SUBJECT: MCGUIRE NUCLEAR STATION, UNITS 1 AND 2 - STAFF ASSESSMENT OF INFORMATION PROVIDED PURSUANT TO TITLE 10 OF THE *CODE OF FEDERAL REGULATIONS* PART 50, SECTION 50.54(f), SEISMIC HAZARD REEVALUATIONS FOR RECOMMENDATION 2.1 OF THE NEAR-TERM TASK FORCE REVIEW OF INSIGHTS FROM THE FUKUSHIMA DAI-ICHI ACCIDENT (TAC NOS. MF3689 AND MF3690)

STAFF ASSESSMENT BY THE OFFICE OF NUCLEAR REACTOR REGULATION

RELATED TO SEISMIC HAZARD AND SCREENING REPORT

WMCGUIRE NUCLEAR STATION, UNITS 1 AND 2

Figure 3.3-1 Plot of Staff's and Licensee's Base Case Shear-Wave Velocity Profiles for the McGuire site

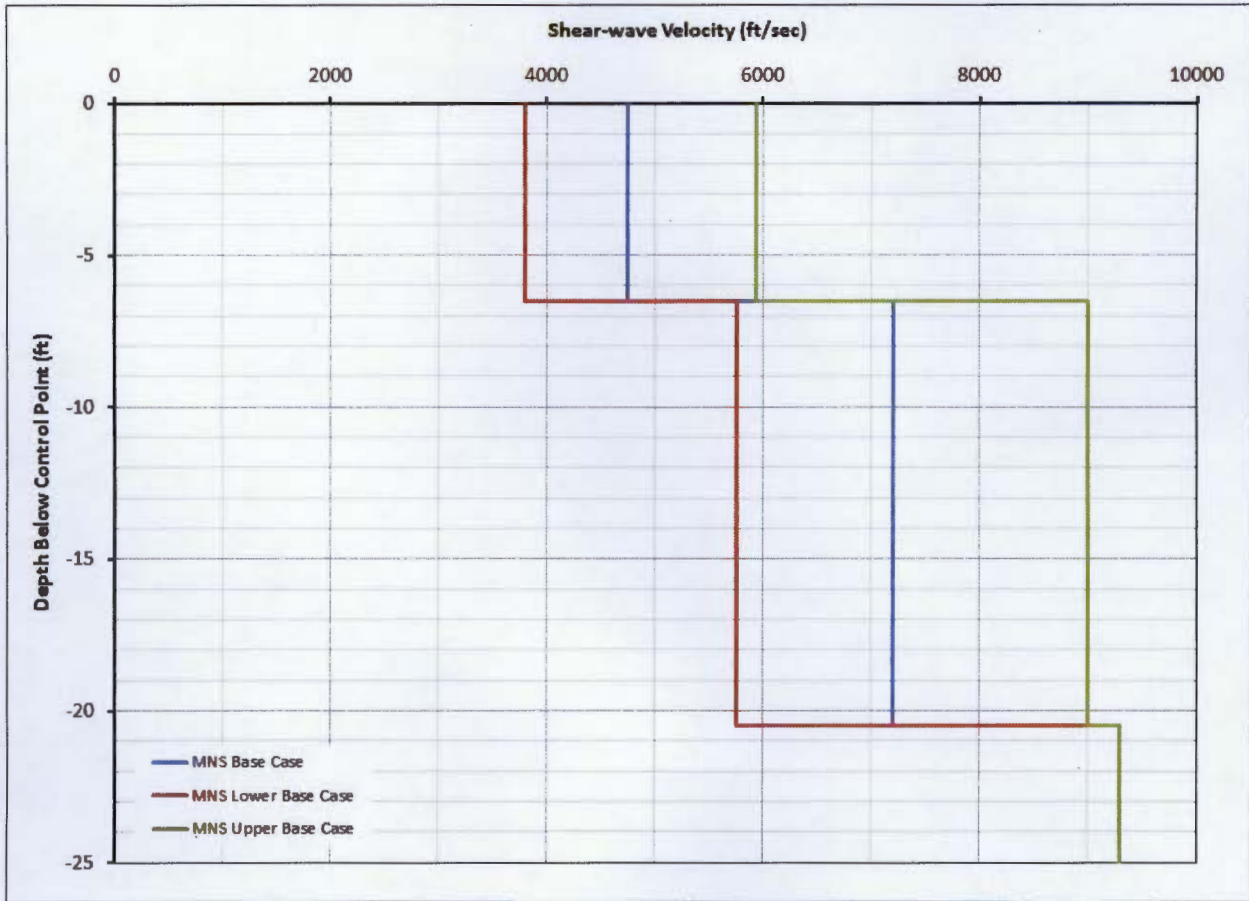
To characterize the uncertainty in the subsurface rock properties, the licensee developed three site base case profiles at the McGuire site. The licensee developed the upper and lower base case profiles by assuming a natural log standard deviation of 0.20 about the middle or best case

profile. Figure 3.3-1 of this assessment shows the licensee's three shear-wave velocity base case profiles for the McGuire site.

Figure 3.3-2 Plot Comparing the Staff's and the License's Median Amplification Functions and Uncertainties for two input loading levels for the McGuire site

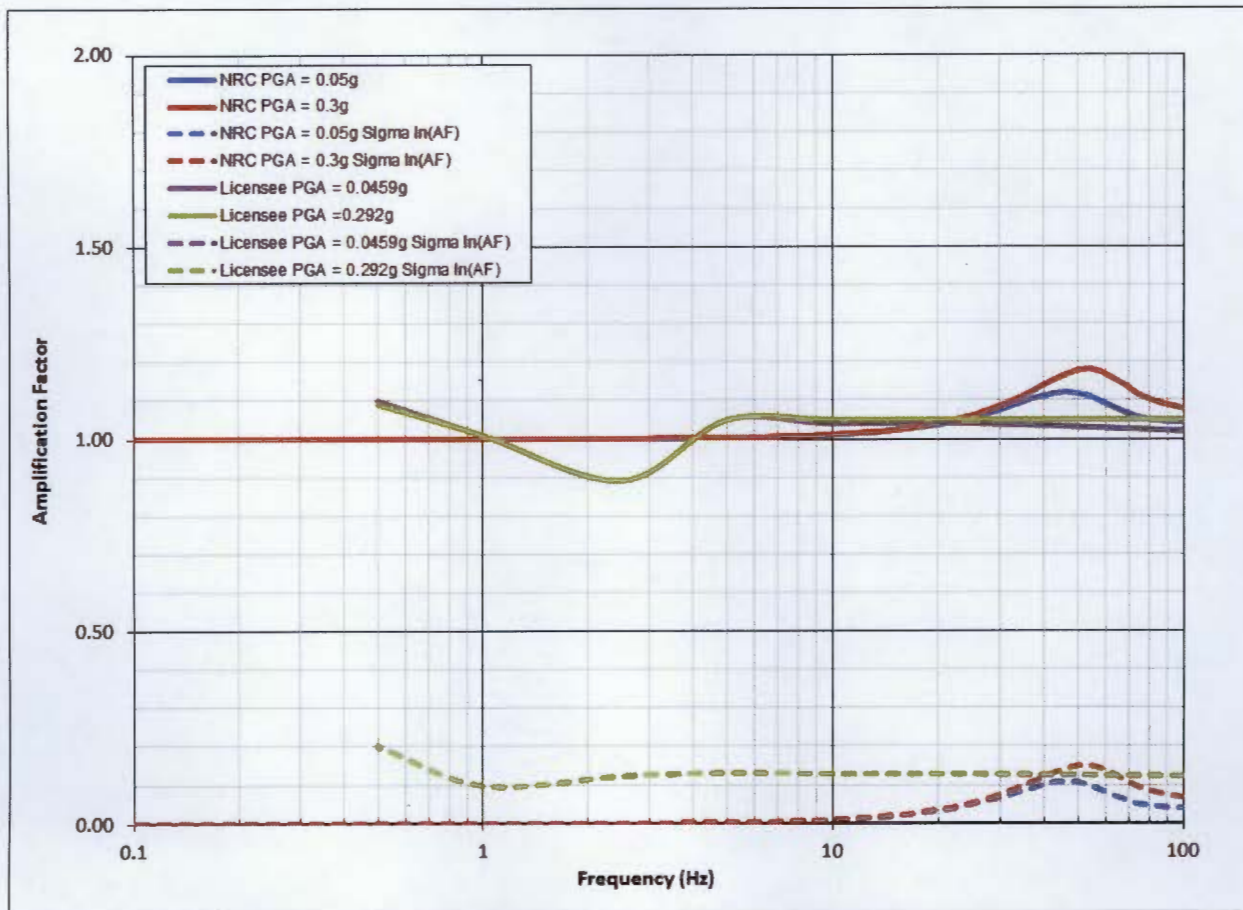
Figure 3.3-2 of this assessment shows a comparison of the NRC staff's and licensee's median site amplification functions and uncertainties (± 1 standard deviation) for two of the eleven input loading levels. Due to the use of very low damping values and modeling of the rock behavior as essentially linear for the range of input loading levels, the NRC staff's confirmatory amplification factors are essentially one for the entire frequency range. Although the licensee assumed non-linear behavior for the firm rock for the entire profile, as well as higher damping values to model the linear behavior, because the profile is relatively shallow, the licensee's amplification functions are also flat over the entire frequency range for the two loading levels shown in the SHSR.

As described above, the NRC staff conducted multiple confirmatory sensitivity tests to evaluate the licensee's characterization of the site subsurface properties, as well as the uncertainties associated with the rock properties. The sensitivity tests conducted by the NRC staff did not produce significant changes to the hazard at the site. Based on the sensitivity analyses and the NRC staff's confirmatory calculations, the NRC staff concludes that the licensee's evaluation for the McGuire site adequately captures the site amplification occurring as a result of bedrock ground motions traveling upward through the rock column to the control point elevation.

Figure 3.3-3 Plot Comparing the Staff's and the Licensee's Mean Control Point Hazard Curves at a Variety of Frequencies for the McGuire site

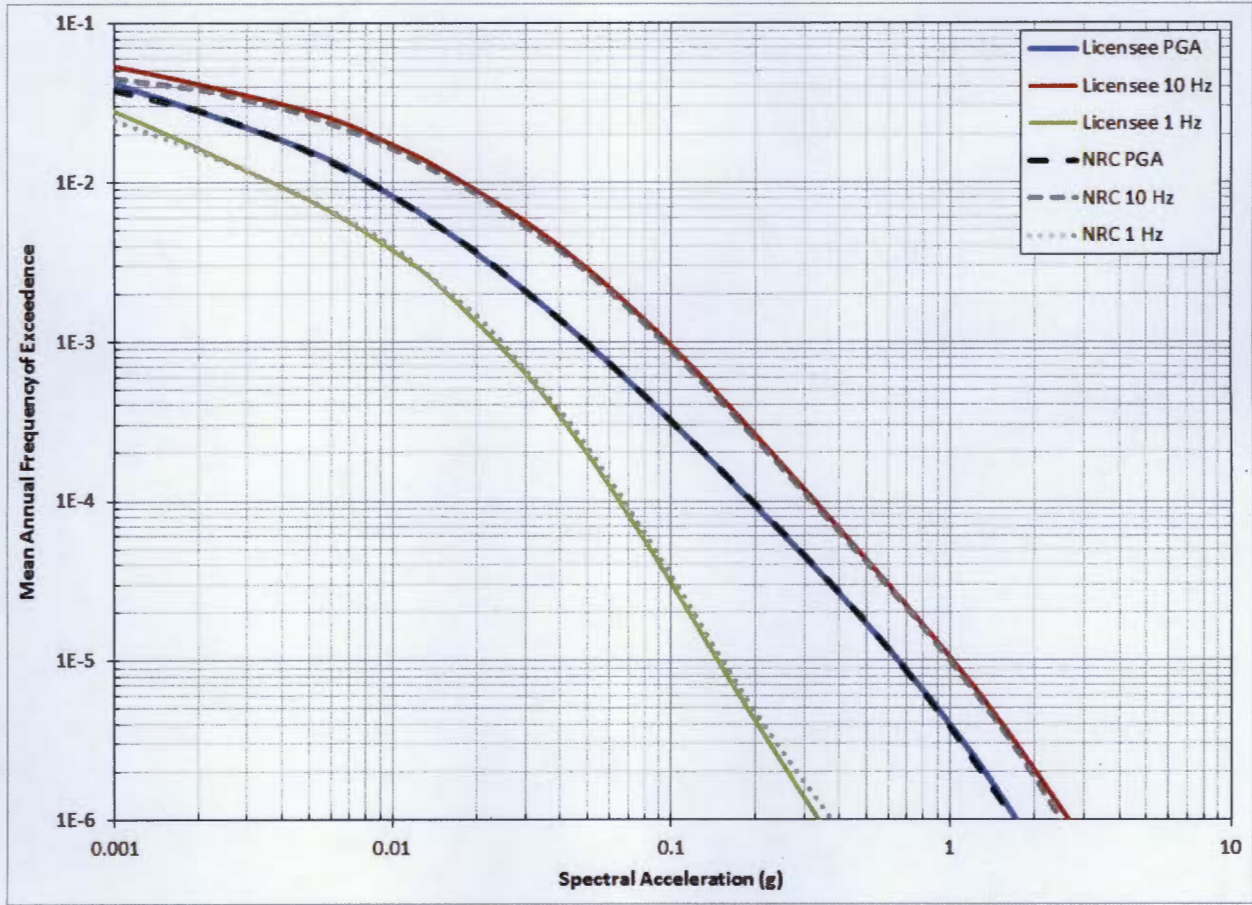
Overall, the licensee's approach to modeling the subsurface rock properties and to modeling their uncertainty results in similar amplification factors as those developed by the NRC staff. As shown in Figure 3.3-3 of this assessment, the NRC staff notes these differences in the site response do not have a large impact on the control point seismic hazard curves or the resulting GMRS, as discussed below. Appendix B of the SPID provides guidance for performing site response analyses, including capturing the uncertainty for sites with less subsurface data; however, the guidance is neither entirely prescriptive nor comprehensive. As such, various approaches in performing site response analyses, including the modeling of uncertainty, are acceptable for the 50.54(f) response.

Figure 3.4-1 Comparison of the Staff's GMRS with Licensee's GMRS and the SSE for the McGuire site

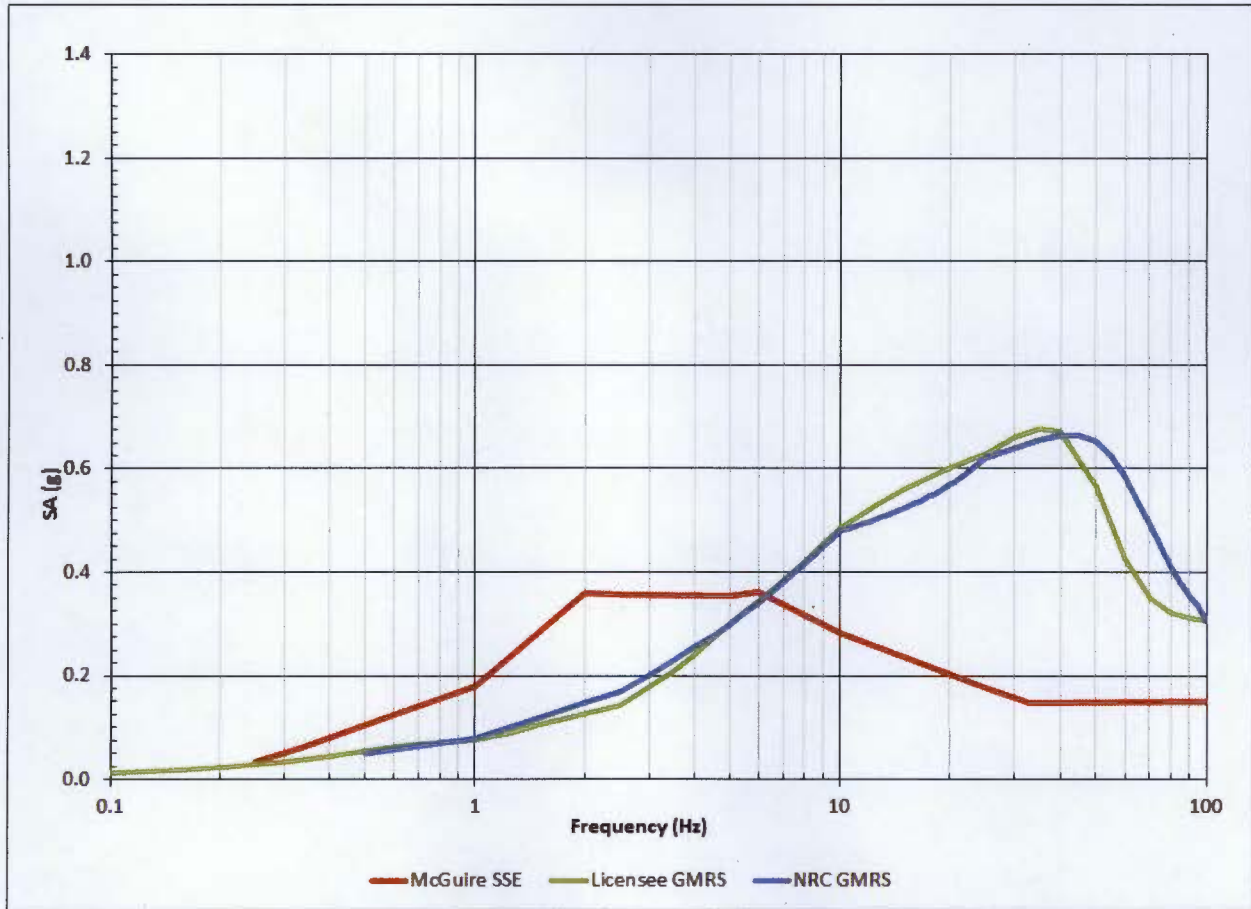
The NRC staff independently calculated the 10^{-4} and 10^{-5} UHRS using the results of its confirmatory PSHA and site response analyses, as described in Sections 3.2 and 3.3 of this staff assessment, respectively. Figure 3.4-1 of this assessment shows a comparison of the GMRS determined by the licensee to that determined by the NRC staff.

As shown in Figure 3.4-1, the licensee's GMRS shape is generally similar to that calculated by the NRC staff at frequencies less than 45 Hz. However, the NRC staff's confirmatory GMRS is somewhat higher than the licensee's at frequencies above 45 Hz. As described above in Section 3.3, the NRC staff concludes that these minor differences over the higher frequency range are primarily due to the differences in the site response analyses performed by the licensee and staff. The NRC staff concludes that the differences between the two GMRS are acceptable for this application because the licensee followed the guidance provided in the SPID with respect to both the PSHA and site response analysis for the McGuire site.

The staff confirms that the licensee used the present-day guidance and methodology outlined in RG 1.208 and the SPID to calculate the horizontal GMRS, as requested in the 50.54(f) letter. The NRC staff performed both a PSHA and site response confirmatory analysis, and achieved results consistent with the licensee's horizontal GMRS. As such, the NRC staff concludes that the GMRS determined by the licensee adequately characterizes the reevaluated hazard for the McGuire site. Therefore, this GMRS is suitable for use in subsequent evaluations and confirmations, as needed, for the response to the 50.54(f) letter.
